Request for Class II Permissive Change(C2PC)

FCC ID: 2AULTEMA34GY-S

This is a C2PC application for which the previous grant was issued on 2025-05-21.

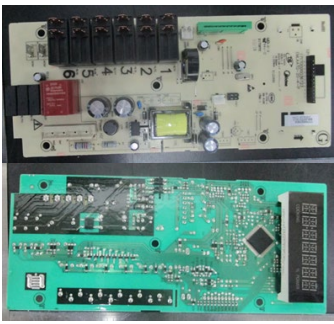
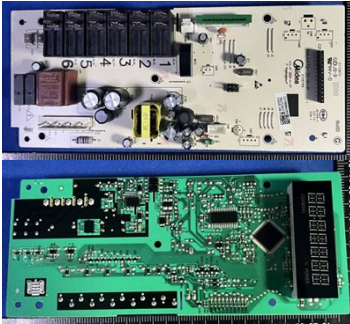
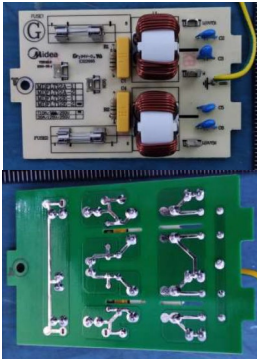
No.:	Original	New	Difference(s)
1			Mother board: Modified the peripheral circuit (non-RF circuit) and some individual components and PCB layout. The magnetron and other circuit are exactly same as before.
2			Filter board: Changed the Y1 capacitor of C5, C2 and C6 to 1000pF 400VAC, and changed the Y1 capacitor of C3 to 470pF 400VAC.
3	N/A		Add a USB interface.
4			Updated front keypad (added the USB function).
